GENWAL MINE 015/032

CHANGE TO THE RECLAMATION PLAN FOR THE

- 1) CRANDALL CANYON MINE MEMORIAL
and the
- 2) PORTAL WATER DISCHARGE
FACILITIES

TASK #3092 (formerly Task #2957)

FIGURE 1

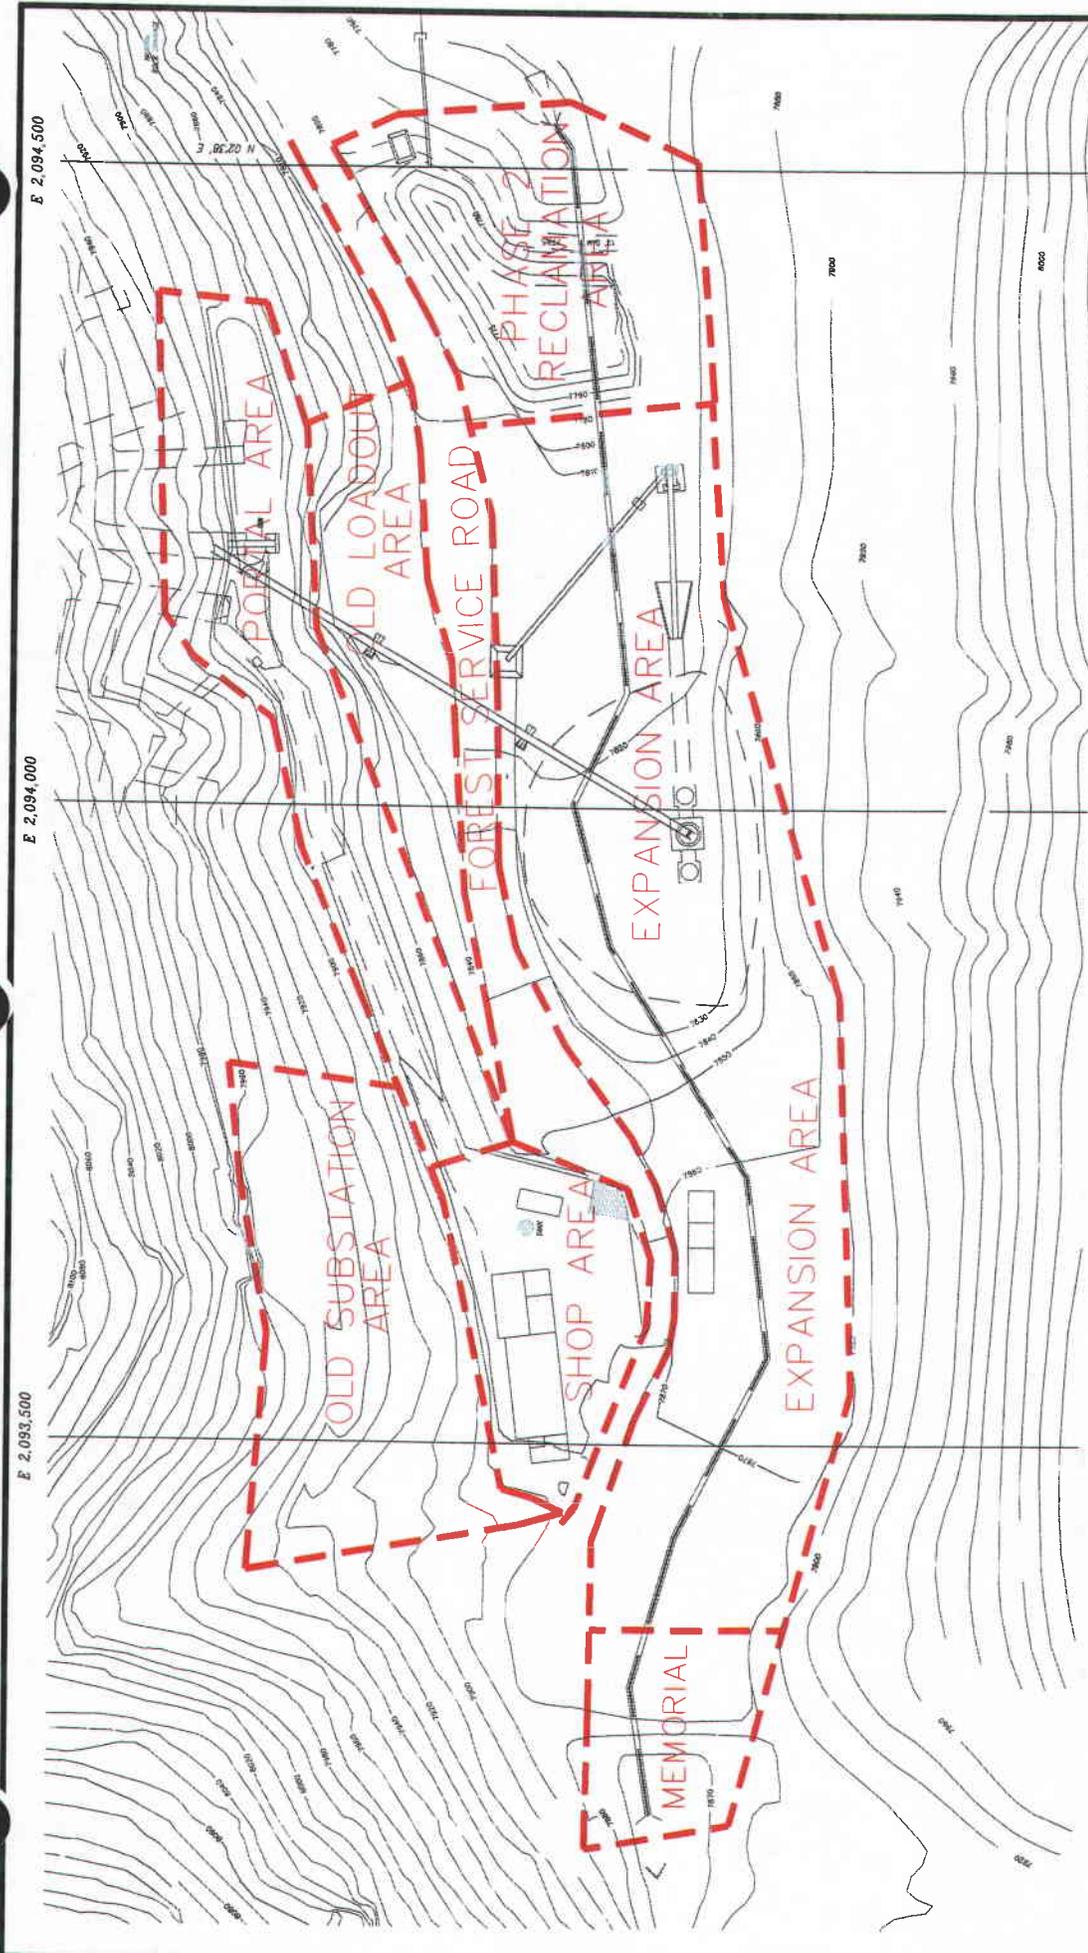
Forest Service Road: The Forest Service Road runs east-west through the mine site. **As a result of construction of the Crandall Canyon Memorial in the summer of 2008, part of this road was deeded to Emery County.** The road is to be kept in place following reclamation activities but will undergo a change in width.

As a result of the Crandall Canyon Mine disaster of August 6, 2007, Genwal deeded a portion of the upper mine yard (Expansion Area) to Emery County to be used as part of a permanent memorial to the deceased miners. (Refer to Appendix 5-27 for details of the deed agreement.) This deeded area measures approximately 150' x 235' (0.0803 acres) and now serves as the parking lot for the memorial, as well as the beginning portion of the trail that leads to the memorial headstones, as shown on Plate 5-3. As well as deeding this area to the County, the company also conveyed to the County a permanent easement for a road through the privately-owned part of the minesite. This road is a continuation of the existing Forest Service road, and will provide permanent public access to the memorial, even after final reclamation of the minesite. Since the parking lot is now owned by Emery County as part of the memorial, the upper end of the Expansion Area, including the initial (upper) 156' segment of bypass culvert running underneath it, will be left in place permanently. Other than leaving this upper area in place, all other elements of reclamation of the Expansion Area, as described herein remain the same.

PLATE 5-16

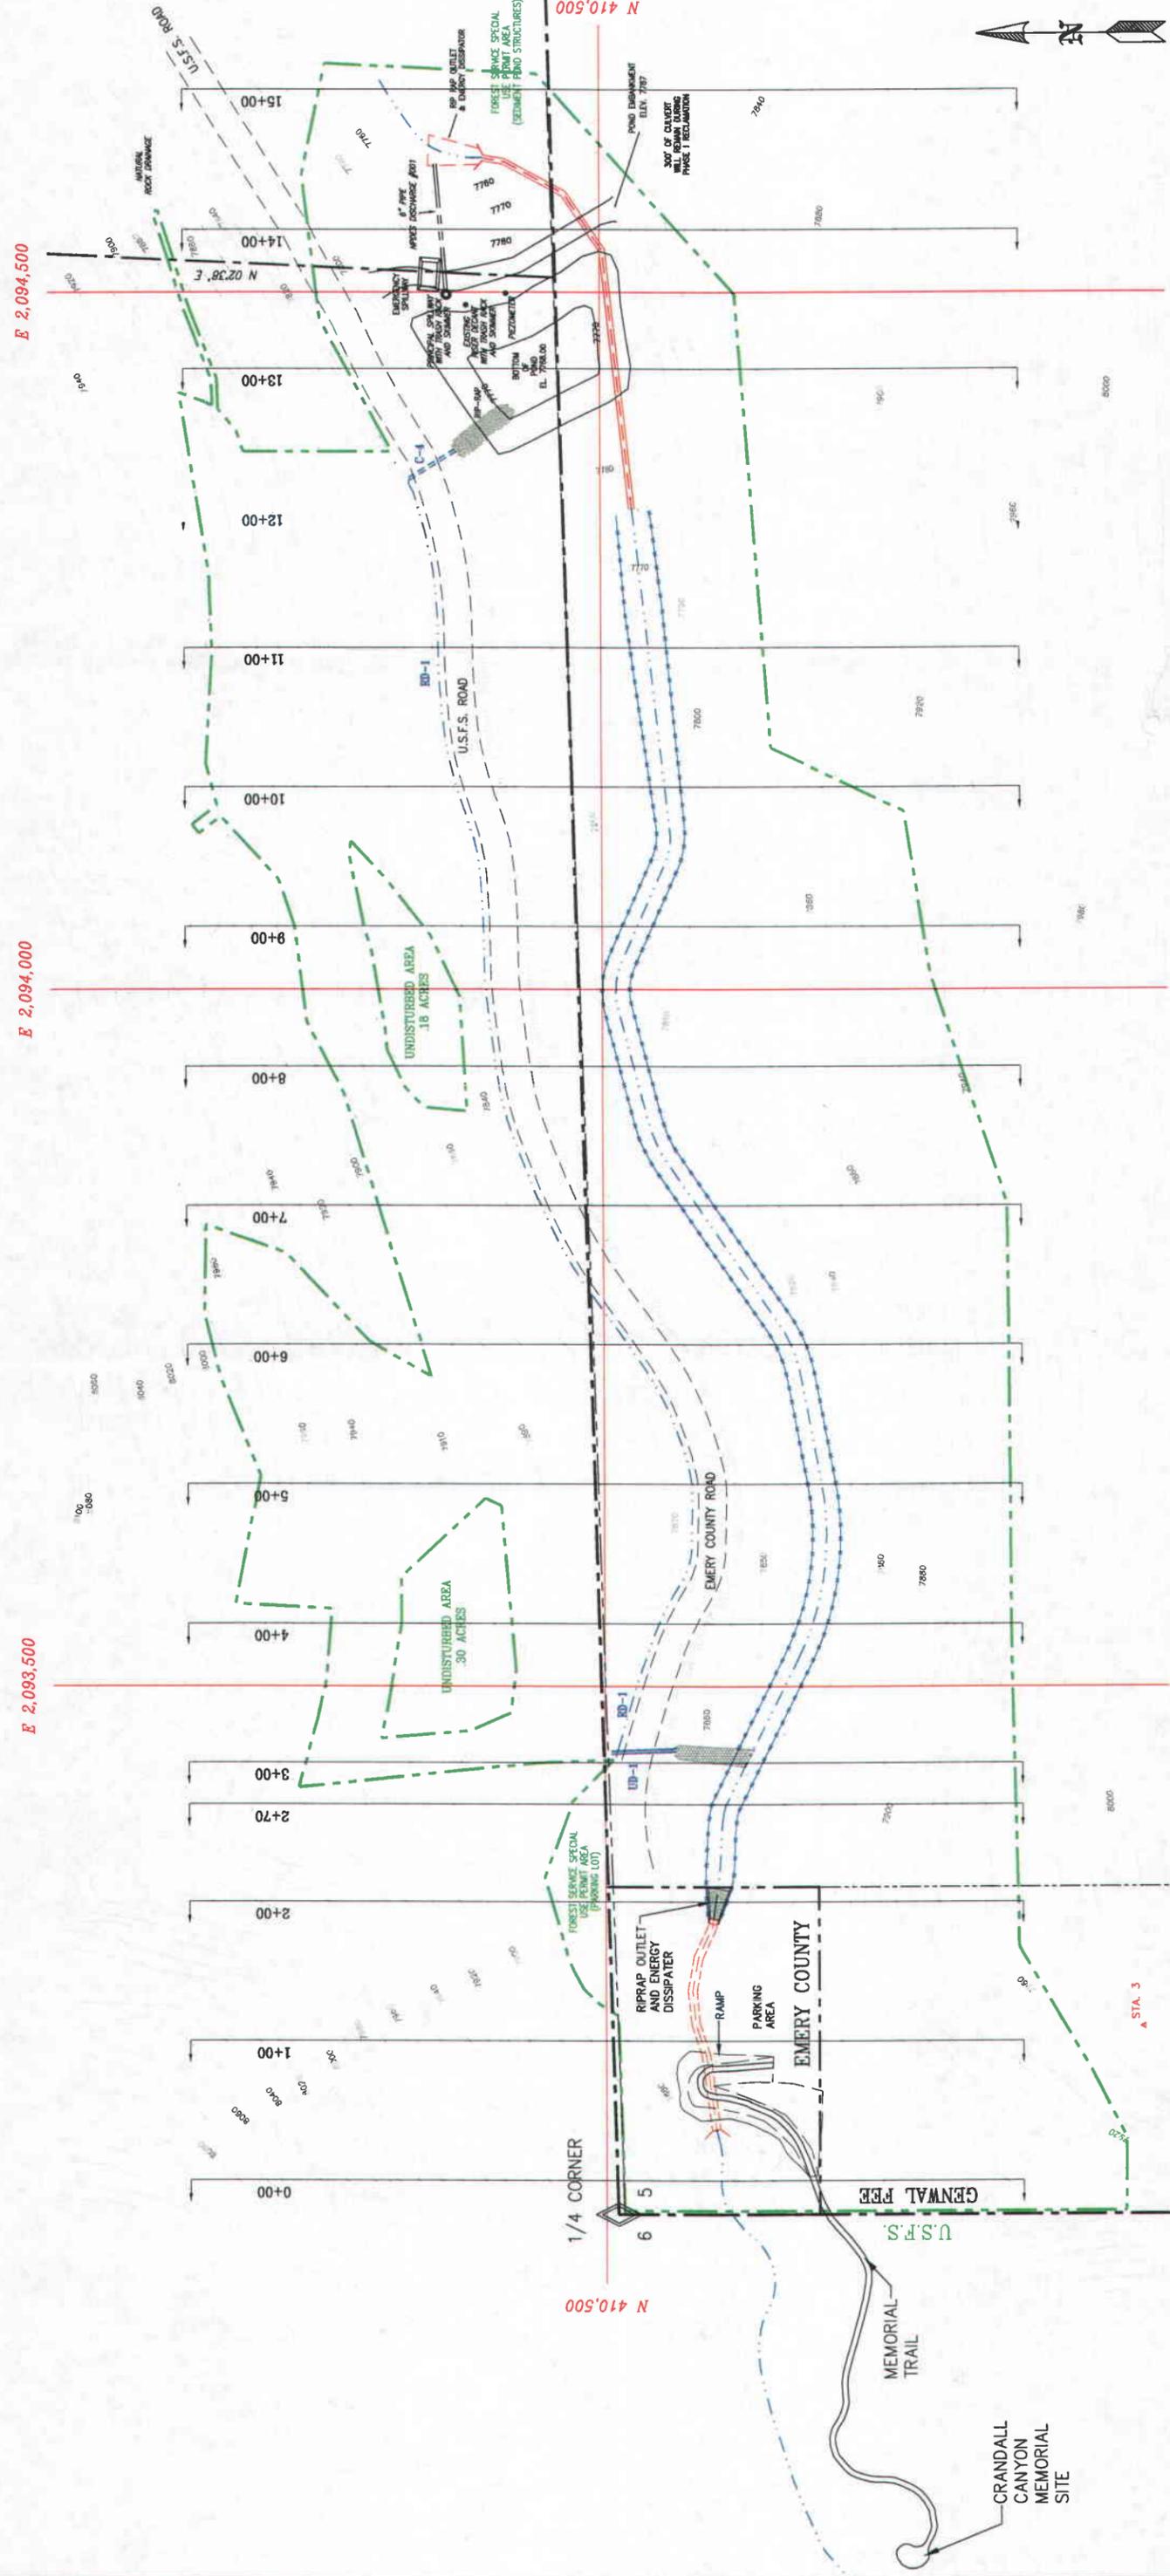
- NOTE:
- 1) SEDIMENT POND WILL STAY IN PLACE DURING PHASE I RECLAMATION.
 - 2) STREAM BED WILL BE RETURNED AS IT PRESENTLY EXISTS BELOW MEMORIAL PARKING AREA.

PLATE 5-17

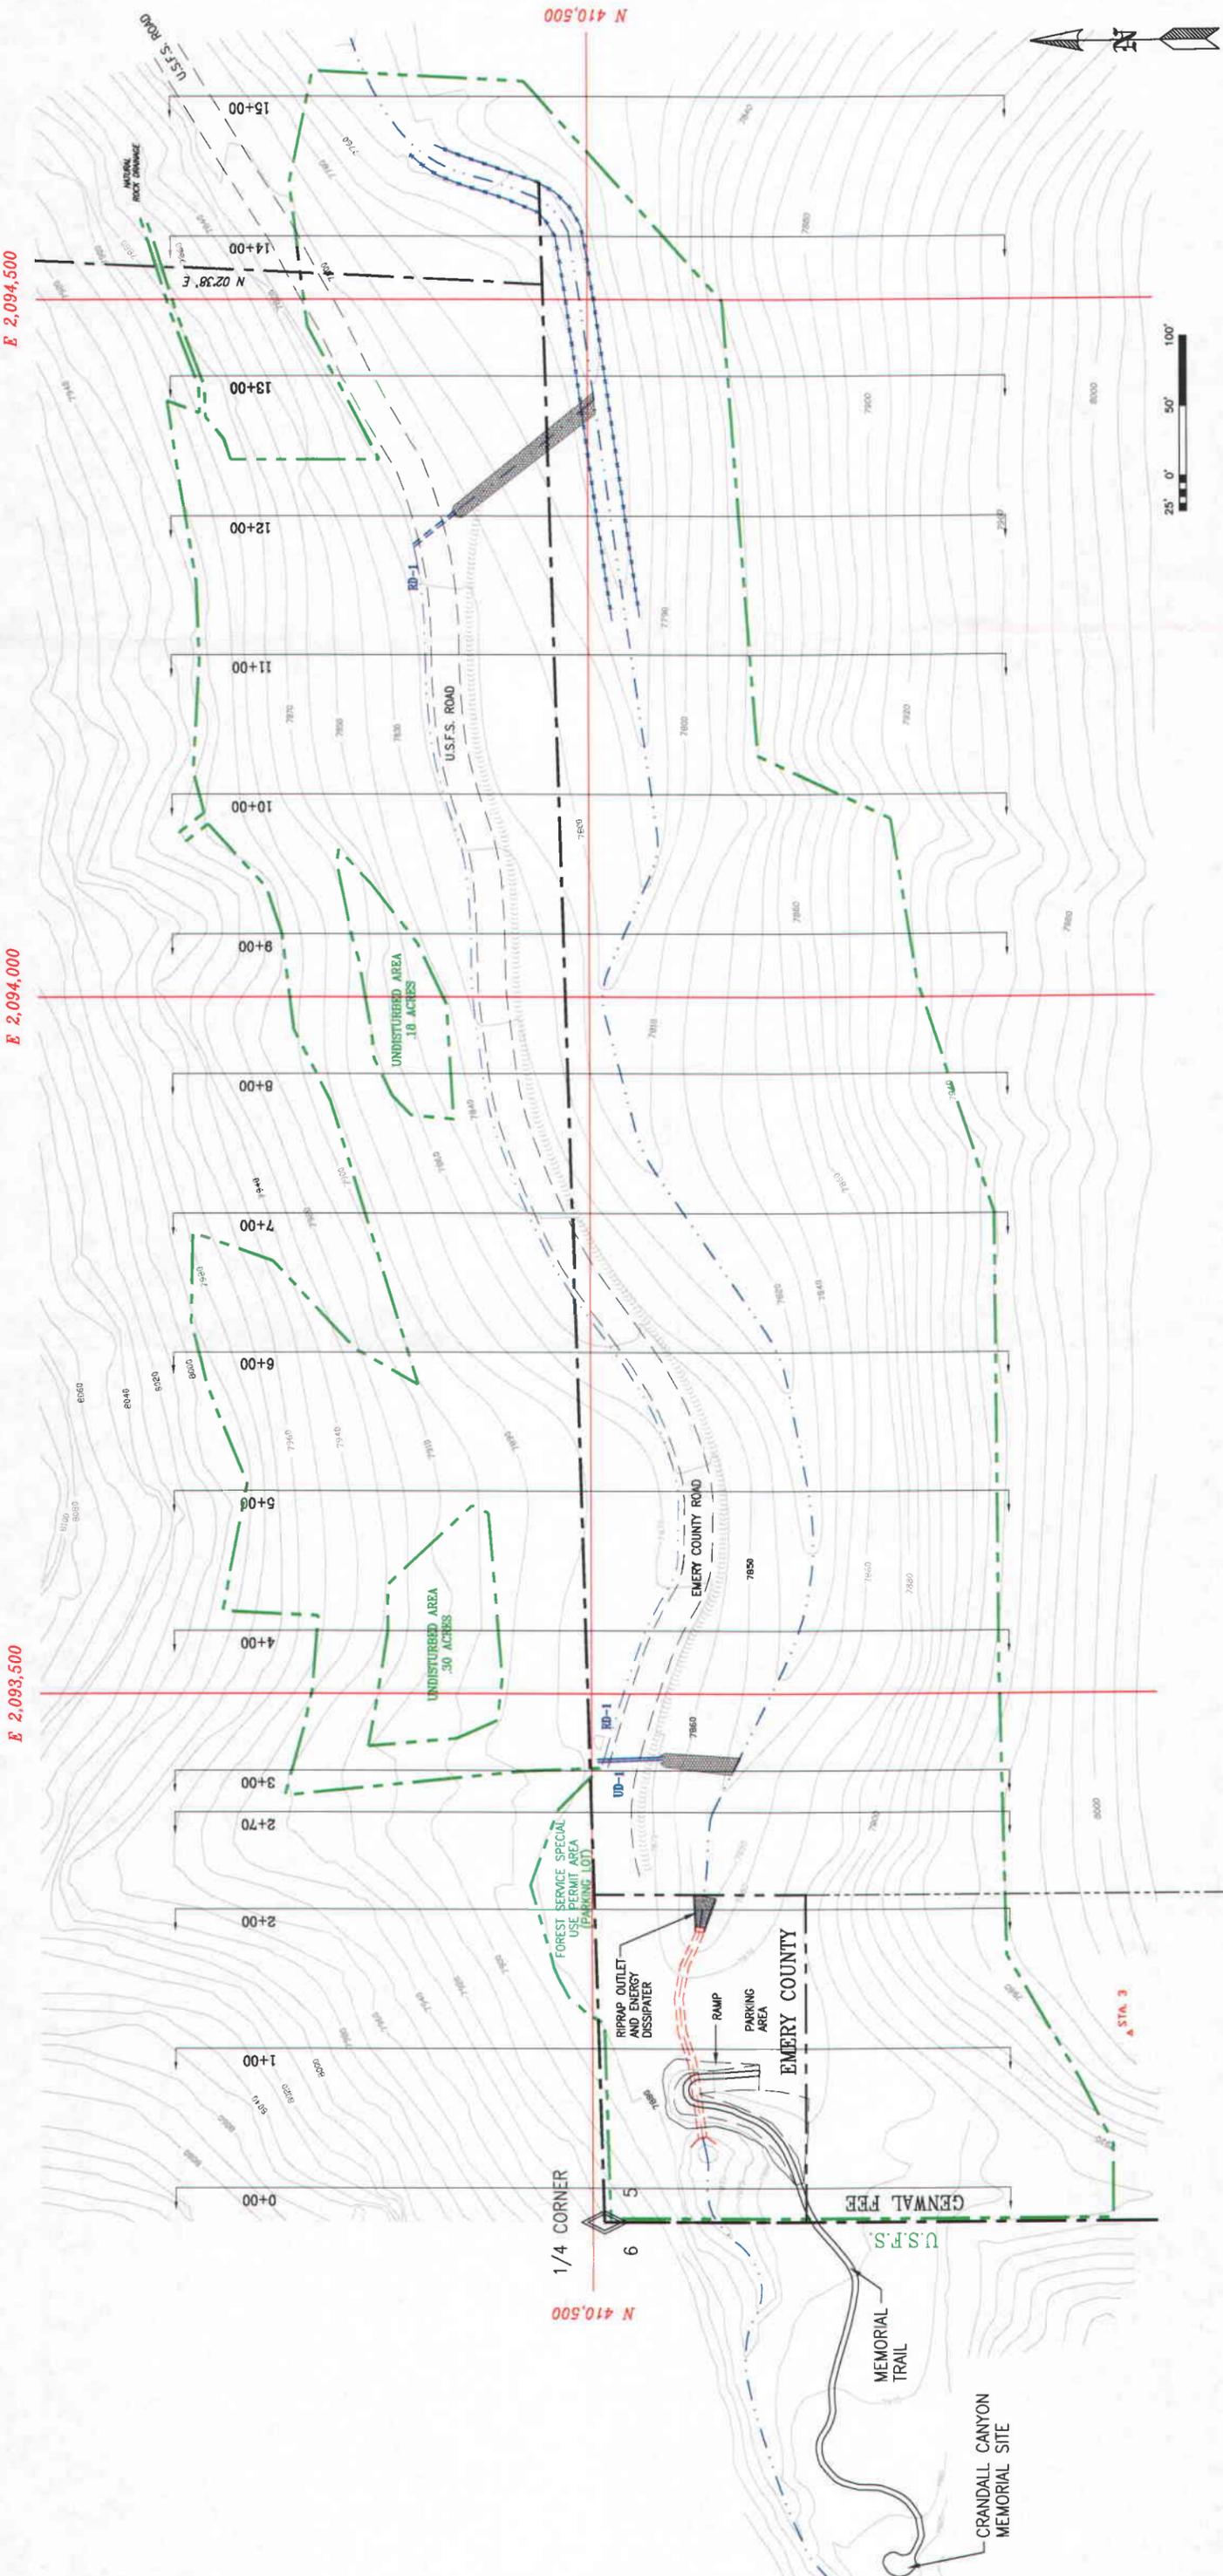
CONTOUR INTERVAL = 10'
 PHOTOGRAPHY DATE = OCTOBER 25, 1989
 NOTE:
 1) STREAM BED WILL BE RETURNED AS IT PRESENTLY EXISTS BELOW MEMORIAL PARKING AREA.
